## **Richfield City Council Agenda**

**Presentation of a revised housing development proposed by Lupe Development for the American Legion site, 6501 Portland Avenue.**

Affordable Housing Development  
6501 Portland Avenue South

Lupe Development - 6501 Portland Ave. S. | Ground Level  
 RICHFIELD, MN | 12.22.2025 | COMM# 47621-25062

GROUND LEVEL  
1" = 30'-0"

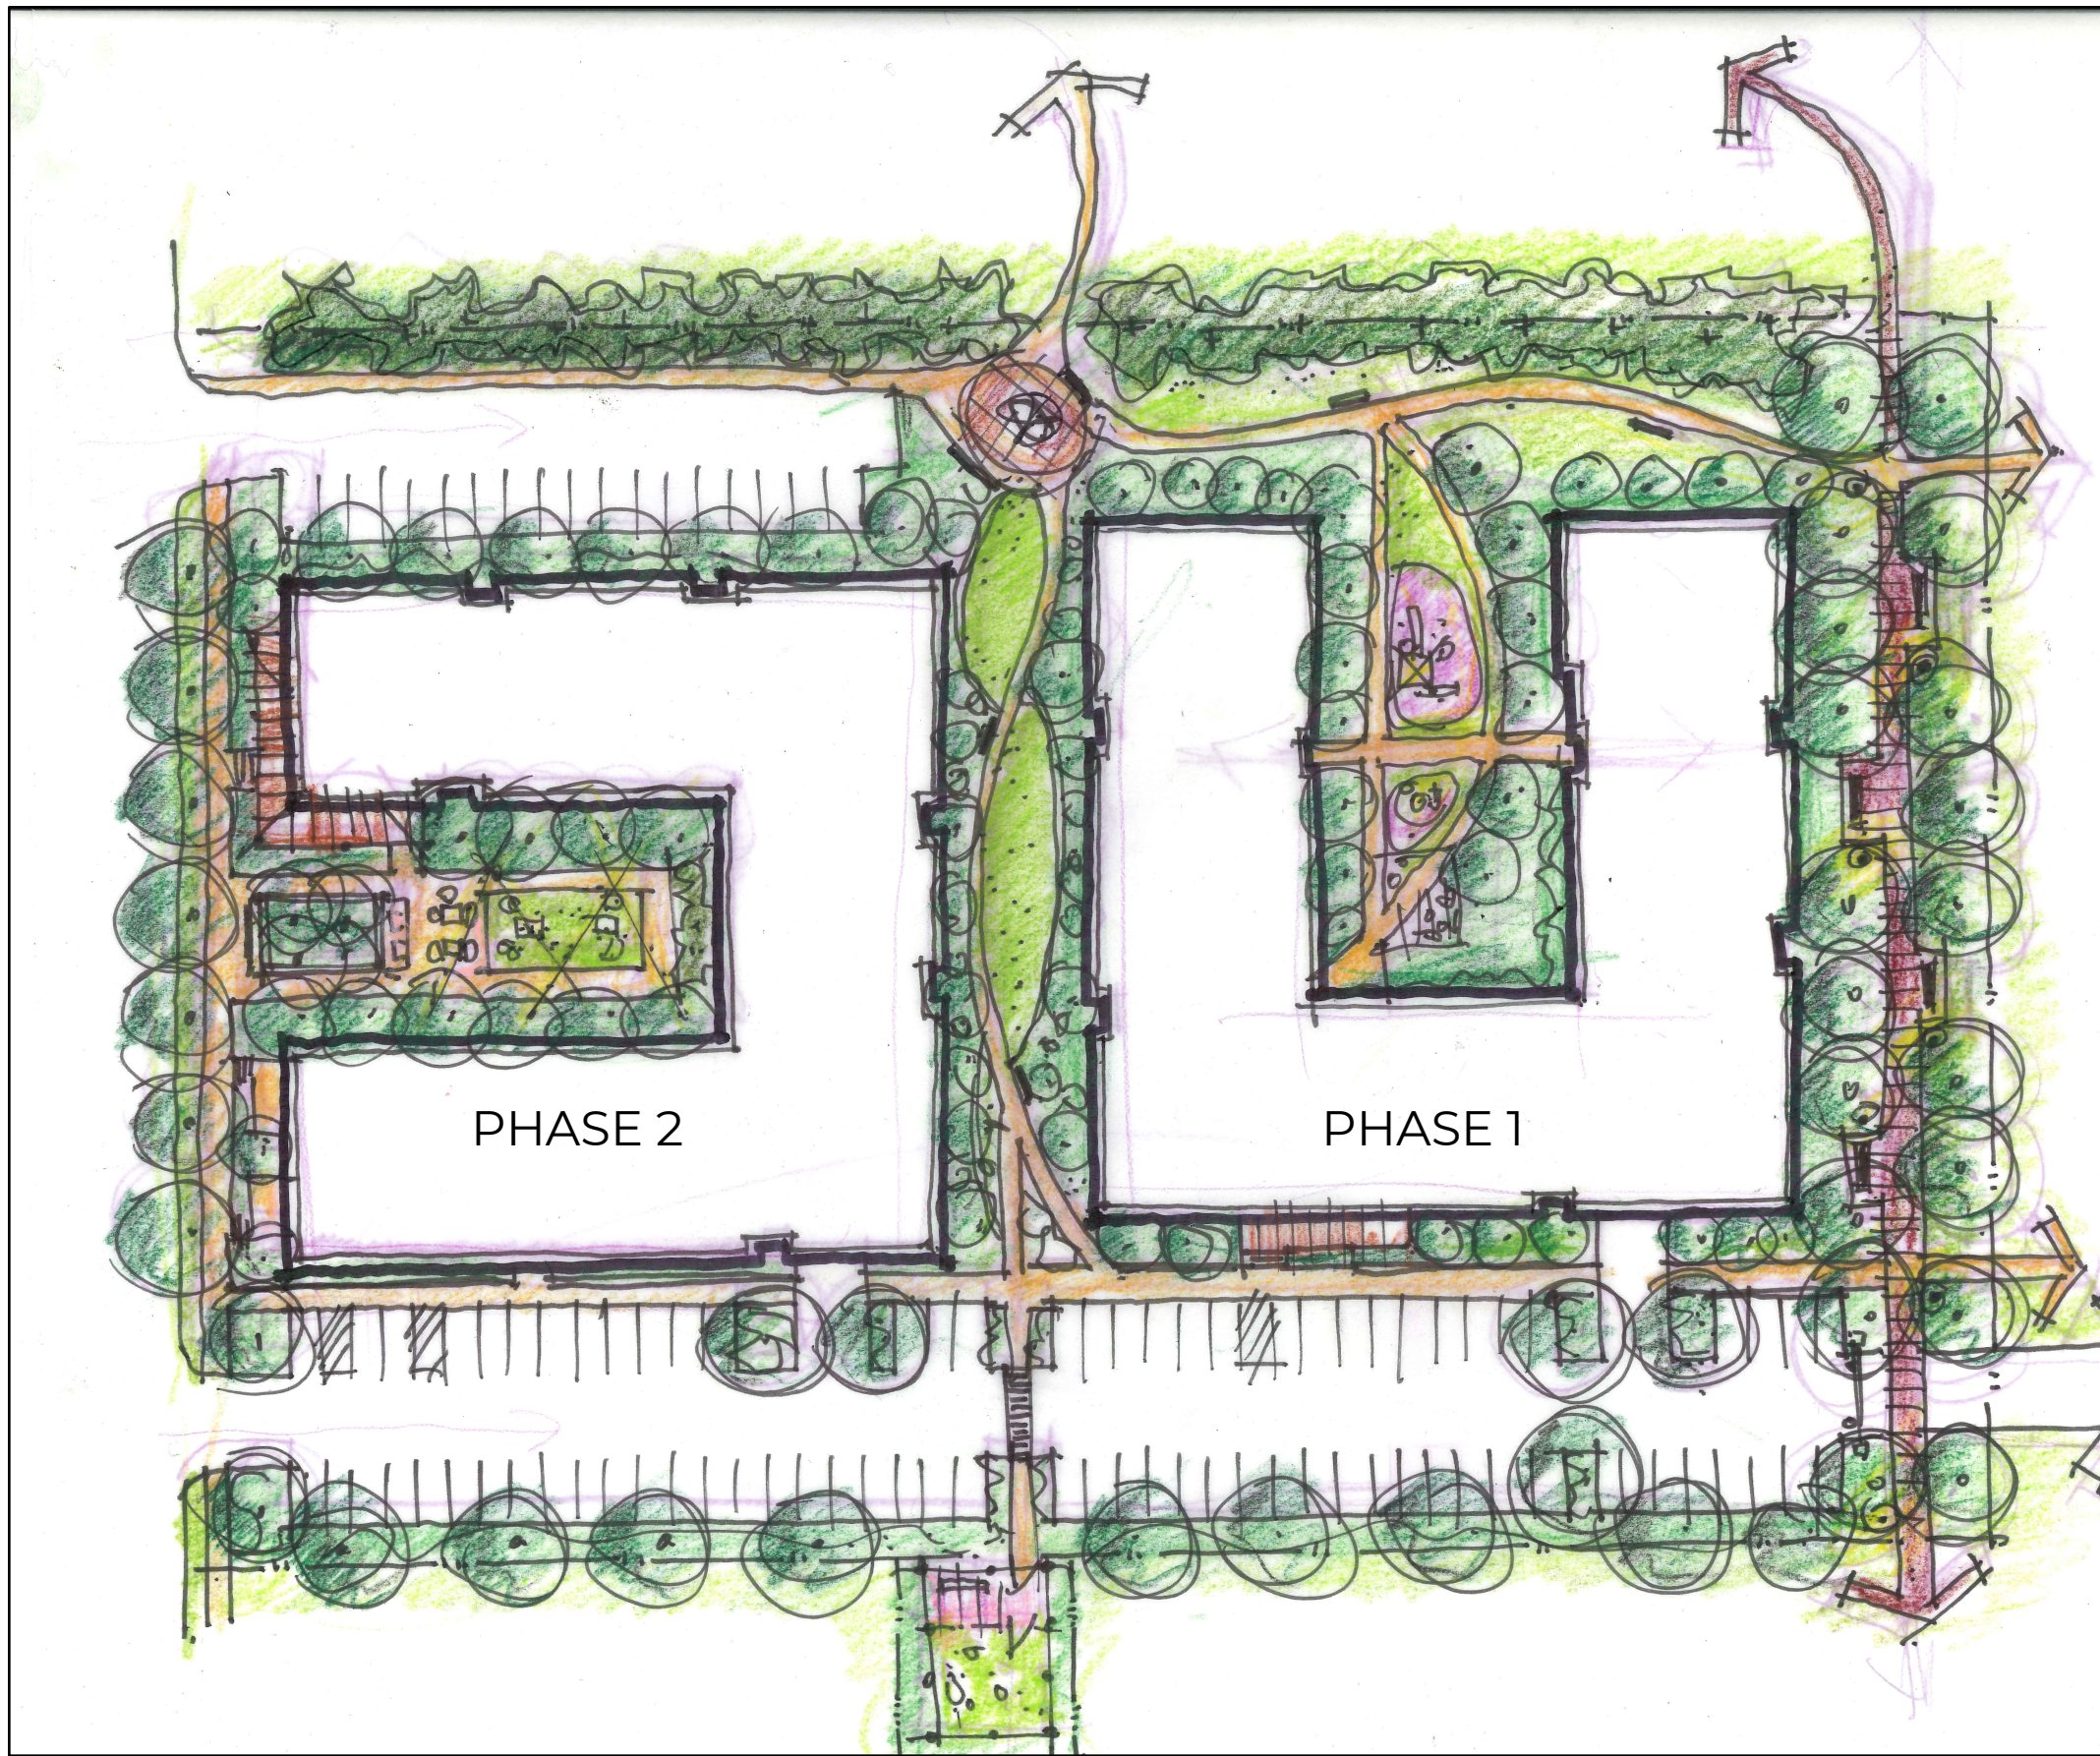
- **The Code requires 333 parking stalls for 296 units and the current plan provides 317 (1.07 stalls/unit), which is a 16-stall deviation. The Code states that the Council may reduce parking requirements for projects designed to serve seniors or other low-driving populations and the Developer has submitted a package that they believe supports this reduction. Accommodation of a future roadway connection to the south would remove approximately 37 planned parking stalls. If parking is determined to be adequate, a traffic impact study will be needed to determine how the project will function until such time that a connection is constructed, or whether there are other methods needed/preferred to serve the site. An ordinance amendment would likely be needed to remove the requirement for a connection.**

- **The Overlay District requires that buildings be stepped back when adjacent to public streets and public land, which encompasses the site's entire perimeter except for the west half of the south side, which abuts private property. The revised plans provide all but one step back. The south side of the eastern building does not step back but does provide a larger setback of approximately 30 additional feet. The Code states that step-backs may be adjusted depending on site conditions, subject to Council approval.**

- **The Overlay District requires the site design to prioritize green space and landscaping in the side and rear setbacks when adjacent to the park (north, east and the east half of the south side). The current plan fills approximately half of these areas with parking; however, Fire Department access must also be considered.**
